**SECTION 00901**

**ADDENDUM NO. 1**

This addendum modifies the Contract Documents dated October 27, 2022, for the San Lorenzo Valley Water District Lyon and Big Steel Zone Pipeline Improvements Project, and the work shall be accomplished in accordance with such modifications. This Addendum includes four (4) pages plus five (5) attachments (total of 29 pages).

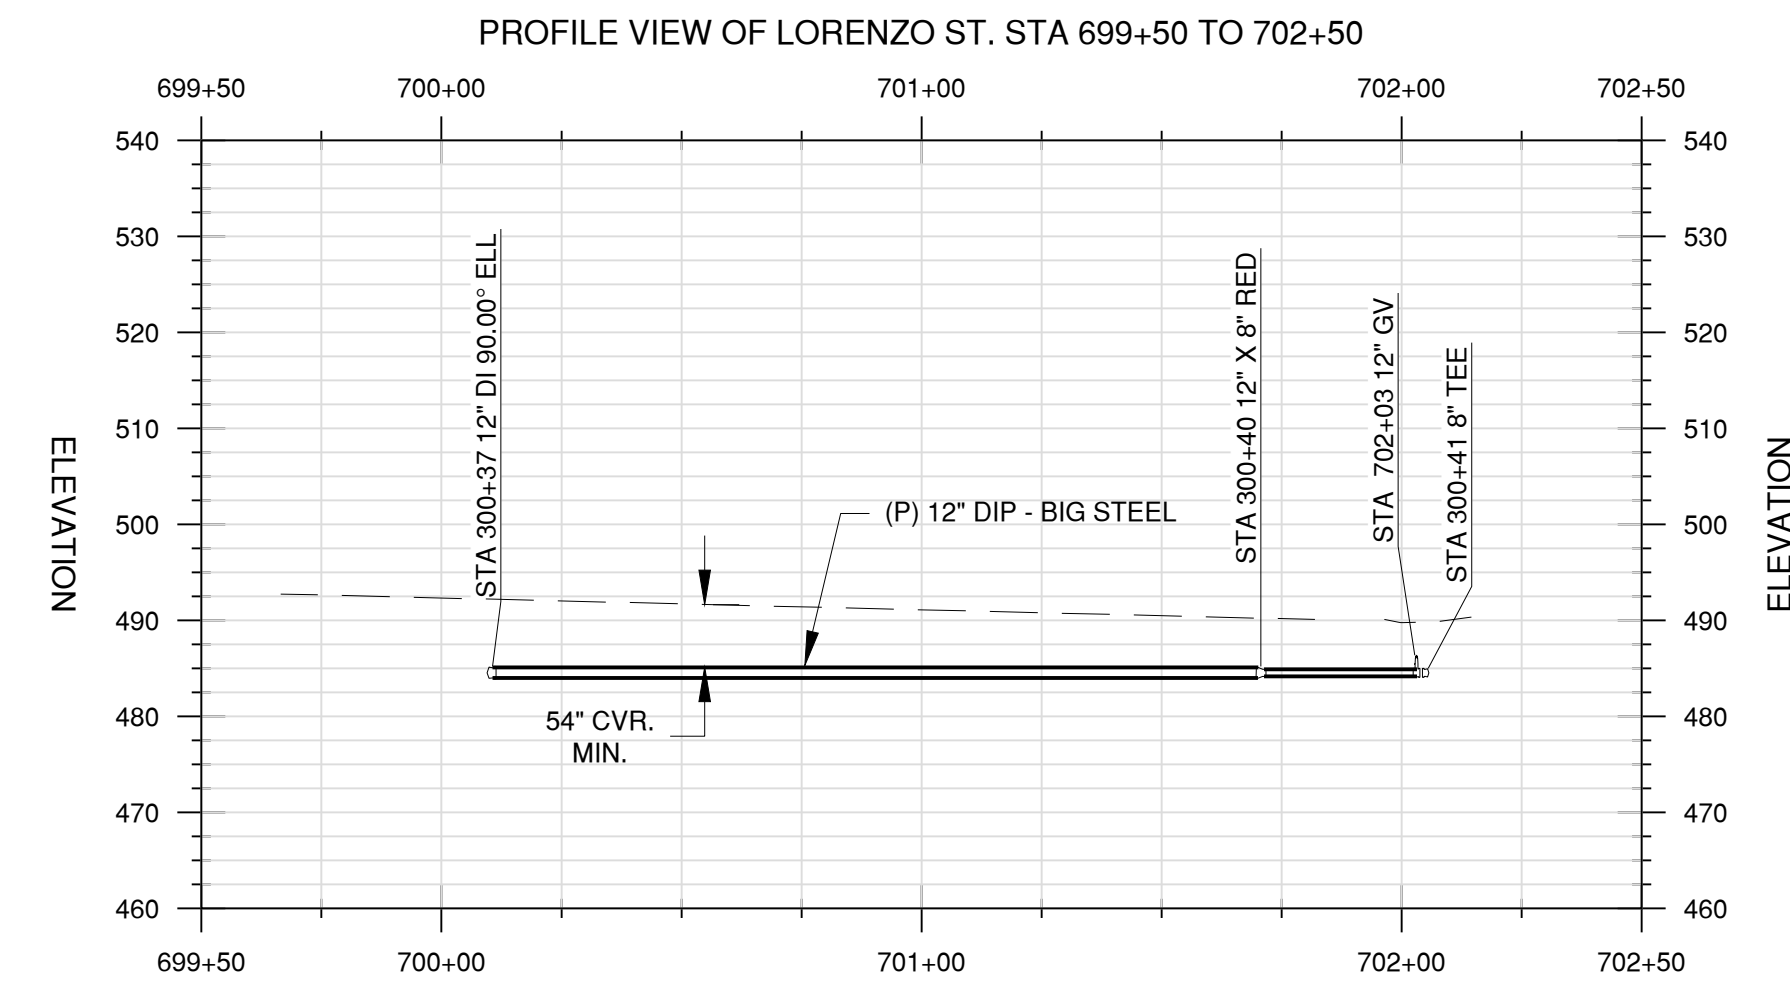
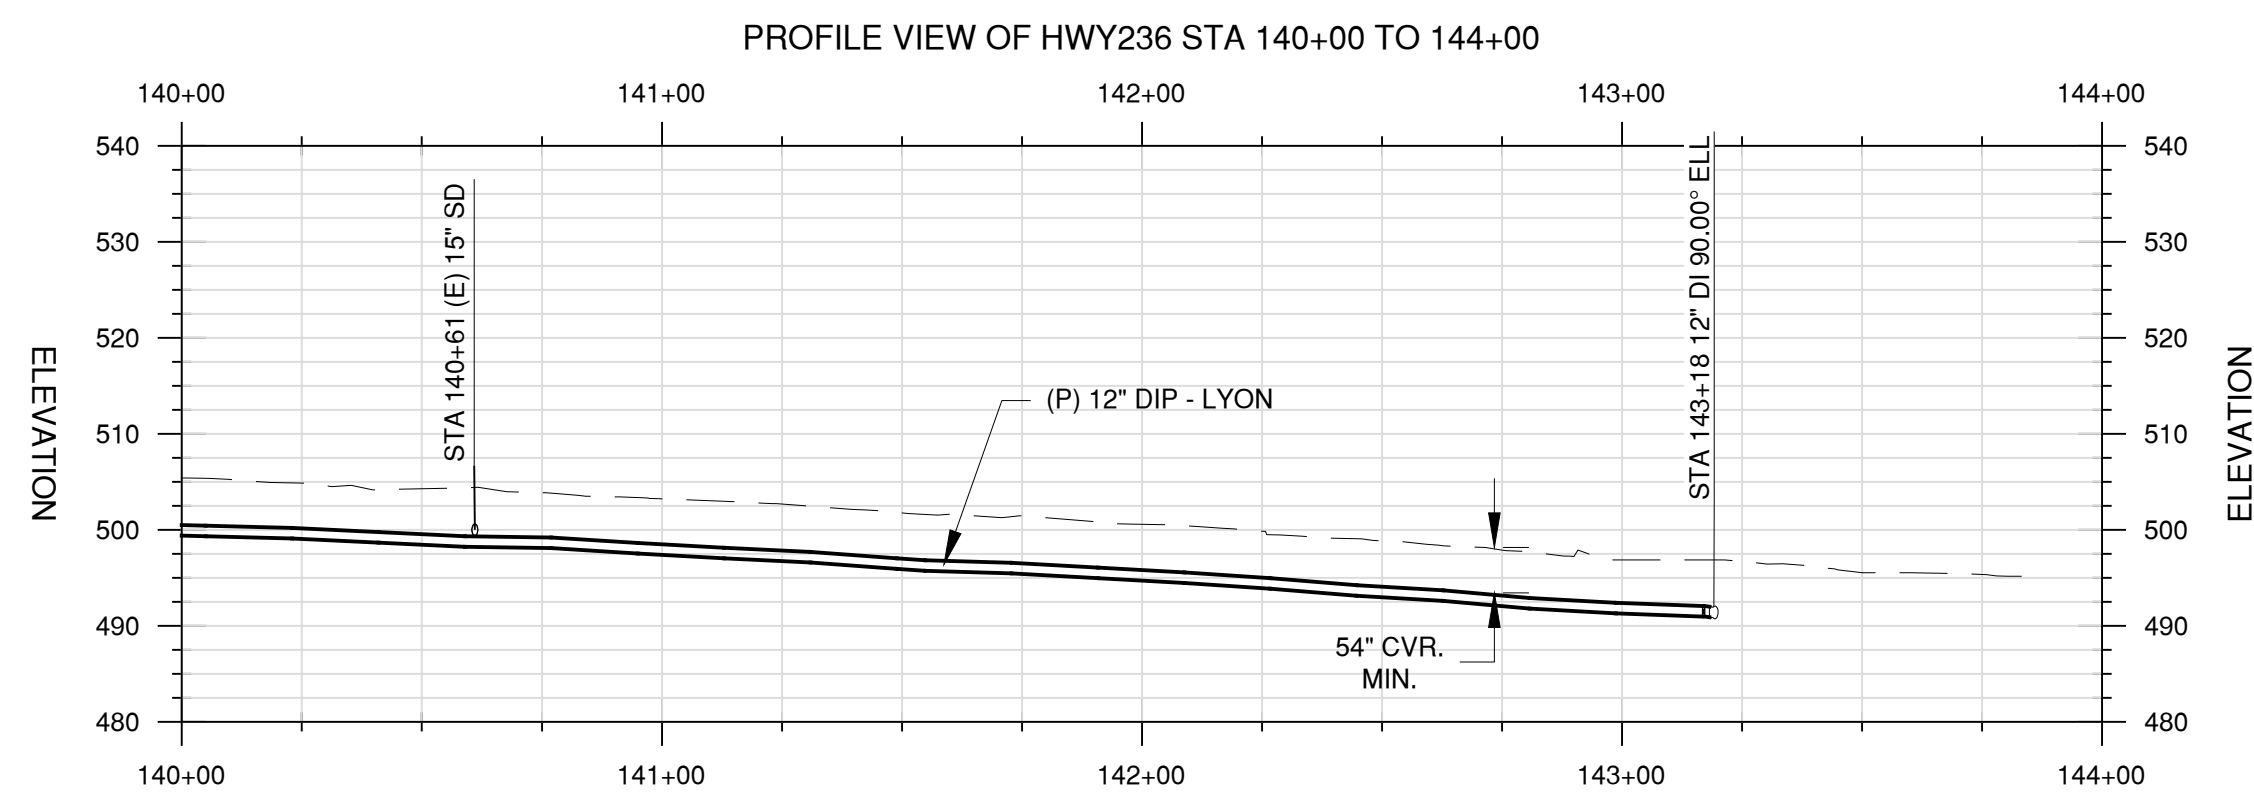
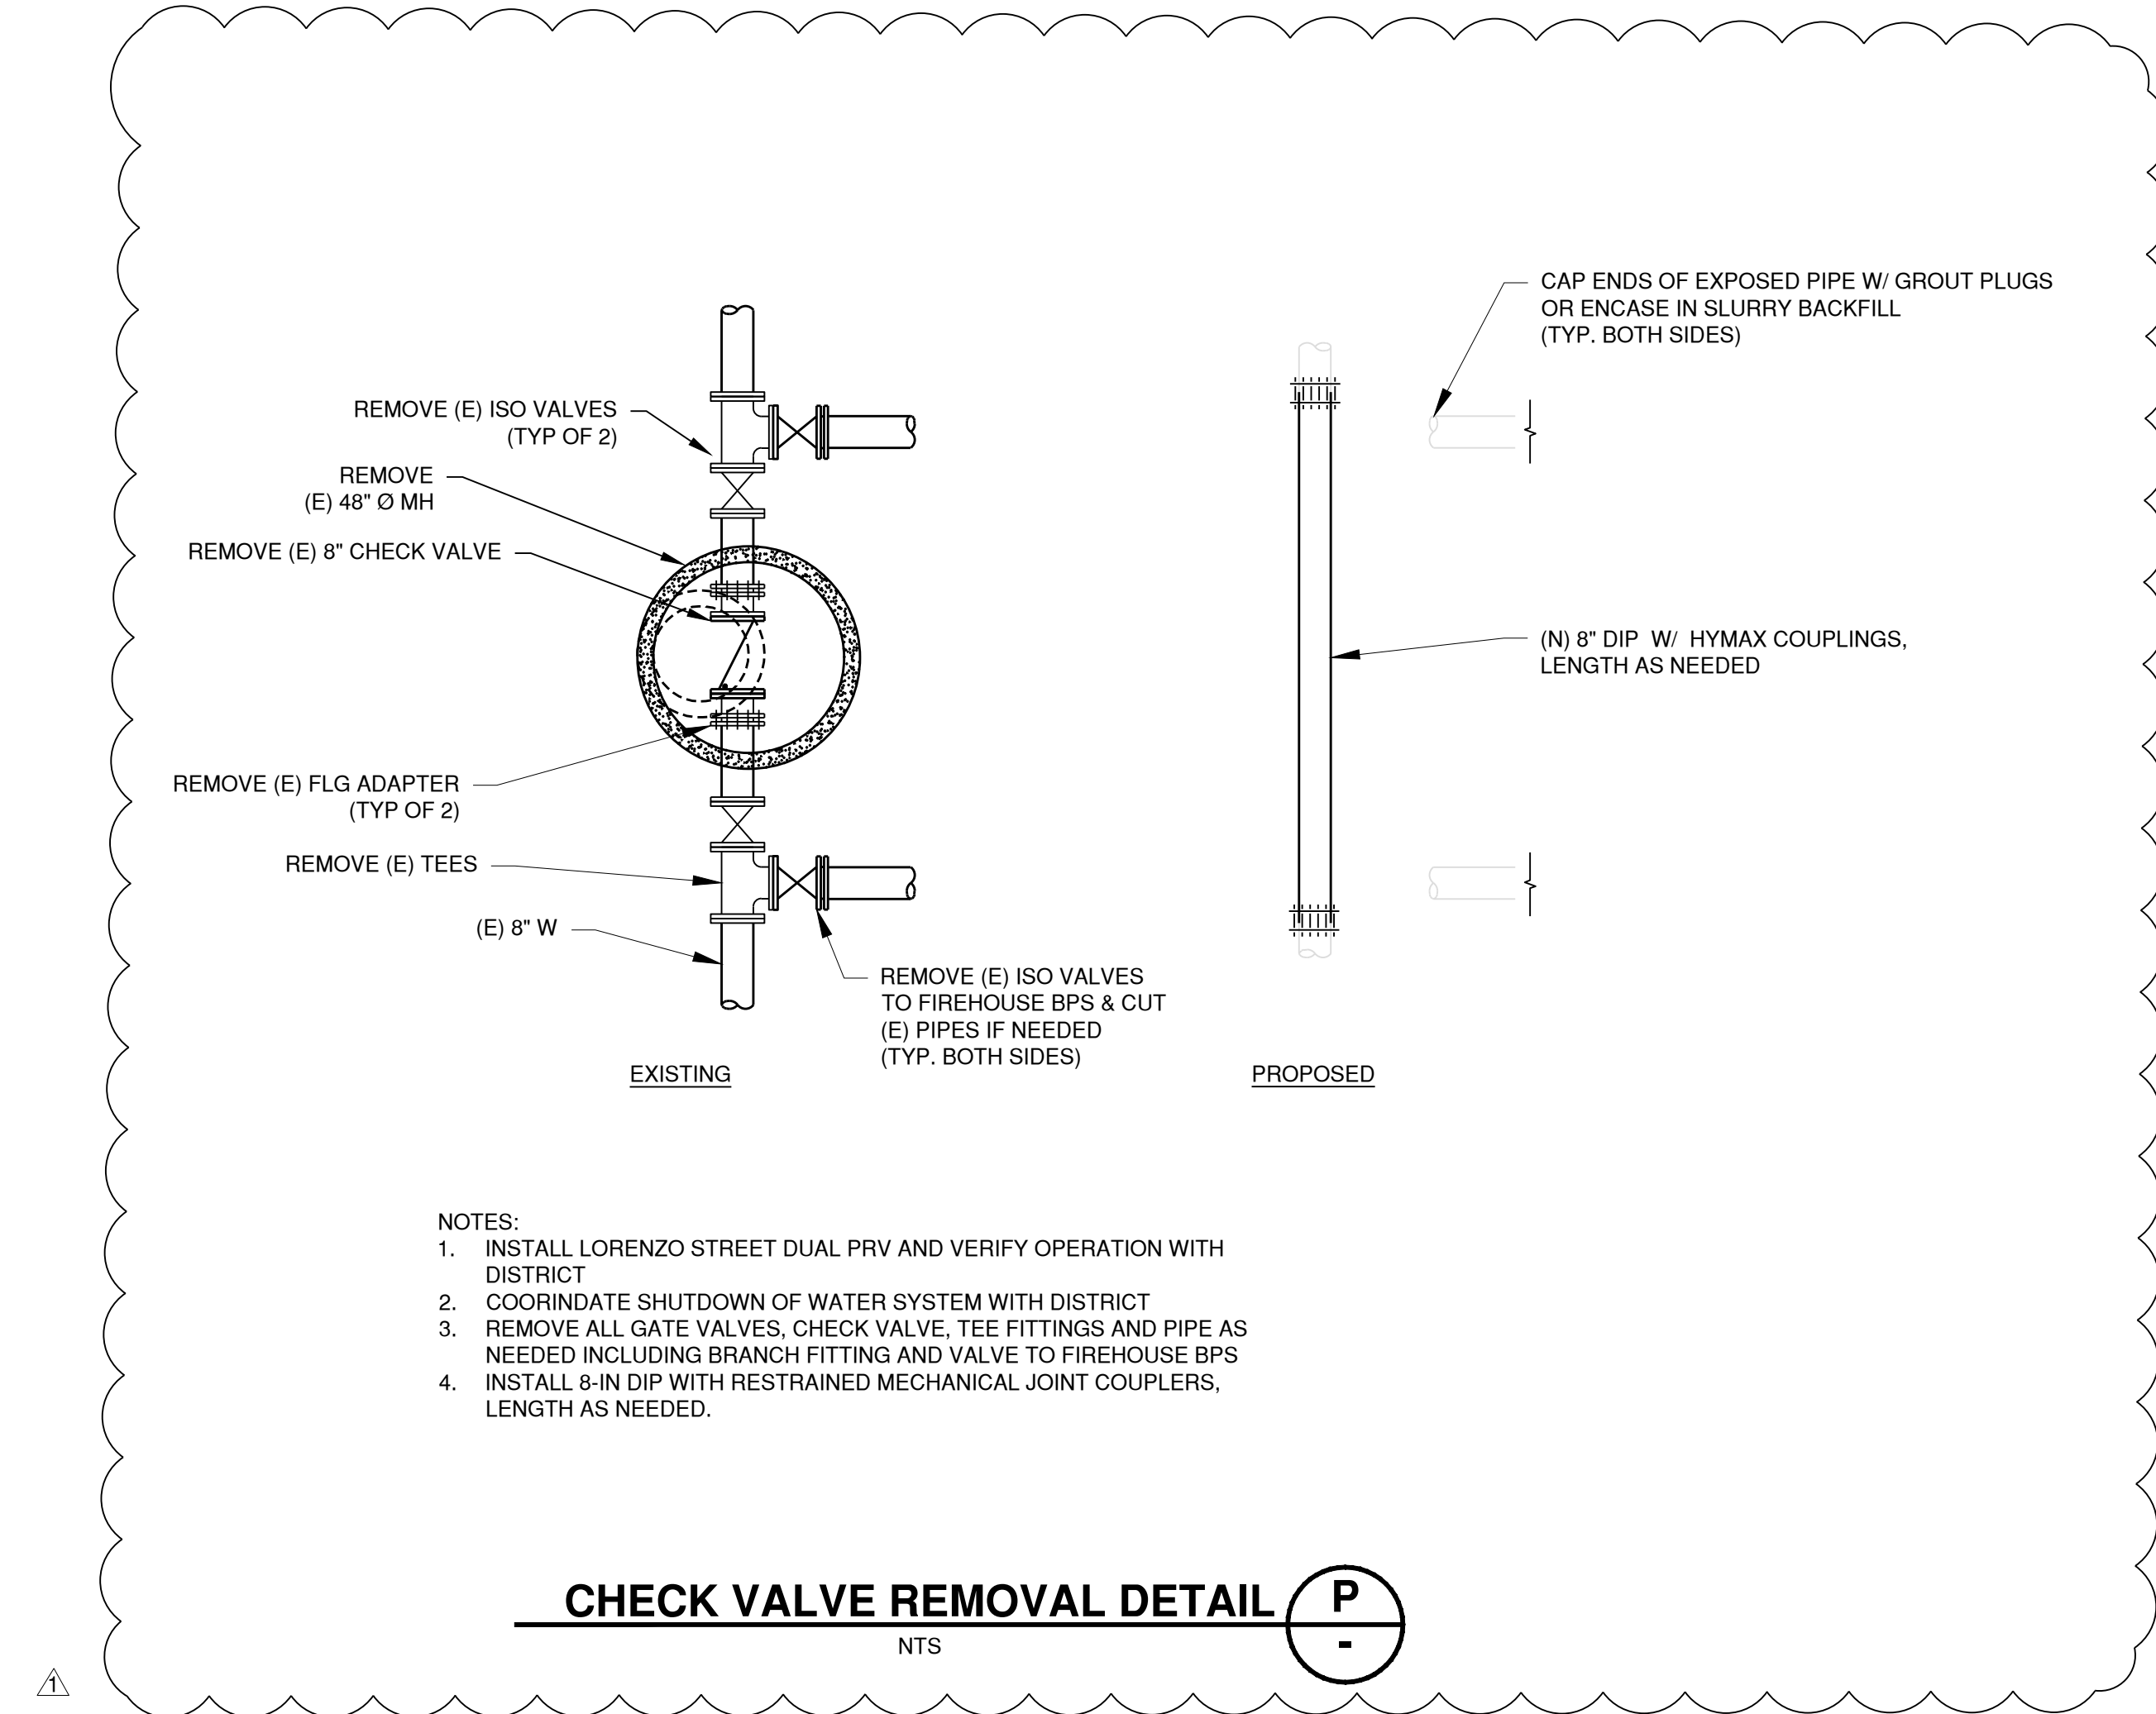
- a. The work in Highway 9 (Main Street) is revised to make the transition simpler. The revised scope is removing the existing check valve, manhole, tees and branch valves and replacing it with a single 8-inch pipe. Decommissioning the rest of the booster pump station will be by District Staff.

"7. Minimum pipe cover shall be 54". When over-crossing other pipelines, the minimum pipe cover shall be 42" within Caltrans ROW, and shall be 36" elsewhere."
- B. Sheet C4.9, Detail P is revised. The changed sheet is attached.
